Economic Commission for Europe**Inland Transport Committee****World Forum for Harmonization of Vehicle Regulations****Working Party on Brakes and Running Gear****Seventy-fourth session**

Tyres – Regulation No. 117**Proposal for amendments to Regulation No. 117****Submitted by the experts from the from the European Commission,
France and European Tyre and Rim Technical Organisation***

The text reproduced below was prepared jointly by the experts from the European Commission (EC), France and European Tyre and Rim Technical Organisation (ETRTO) in order to introduce wet grip provisions and testing procedures for tyres of categories C2 and C3. The document is based on informal documents GRRF-73-08, GRRF-73-18 and GRRF-73-21. The modifications to the existing text of the Regulation are marked in bold for new or strikethrough for deleted characters.

Figure 1
 Nomenclature explanation related to grip index of the tyre

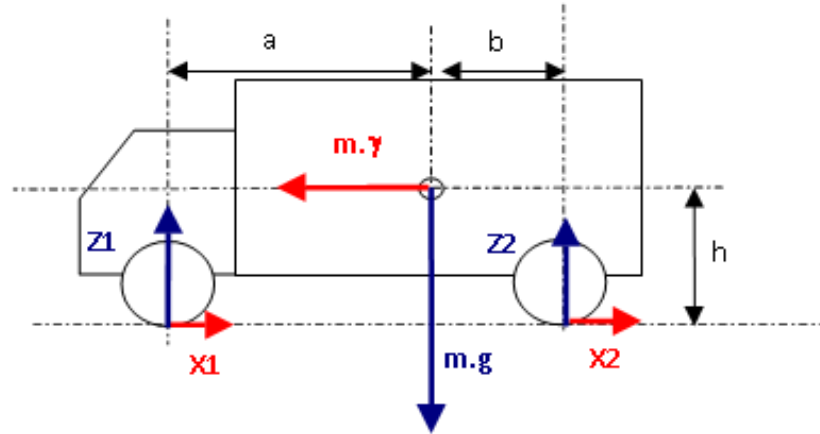
The Wet grip index represents the relative performance of the candidate tyre compared to the reference tyre. The way to obtain it depends on the test configuration as defined in paragraph 2.2.2.2. The wet grip index of the tyre is calculated as reported into Table 3:

Configuration C1: <i>candidate tyres on both axles</i>	$\text{Wet Grip Index} = \frac{BFC(T)}{BFC(R)}$
Configuration C2: <i>candidate tyres on front axle and reference tyres on rear axle</i>	$\text{Wet Grip Index} = \frac{BFC(T)[a + b + h \cdot BFC(R)] - a \cdot BFC(R)}{BFC(R)[b + h \cdot BFC(T)]}$
Configuration C3: <i>reference tyres on front axle and candidate tyres on rear axle</i>	$\text{Wet Grip index} = \frac{BFC(T)[-a - b + h \cdot BFC(R)] + b \cdot BFC(R)}{BFC(R)[-a + h \cdot BFC(T)]}$

N.B. When "h" is not precisely known, these worst case values shall apply: 1,2 for configuration C2, and 1,5 for configuration C3
